## Product Change Notice (PCN)

**Subject:** Add tray and desiccant for RL78 Family LQFP/LFQFP.

# Difference specification (LQFP/LFQFP\_ Add tray & desiccant) 7x7mm,10x10mm,12x12mm,14x14mm

MCP-AB-22-0119  
PC-MCU-A010A/E

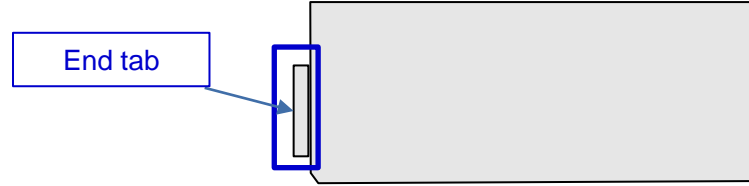
- ✓ Add a tray for the above package.
- ✓ The notation of the end tab is different for the current tray and additional tray.
  - However, the dimensions of the current tray and the additional tray are the same.

# Difference of tray-2

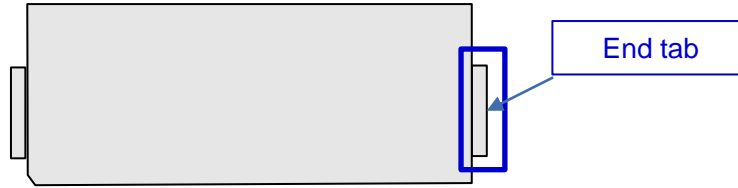
The notation of the end tab is different.
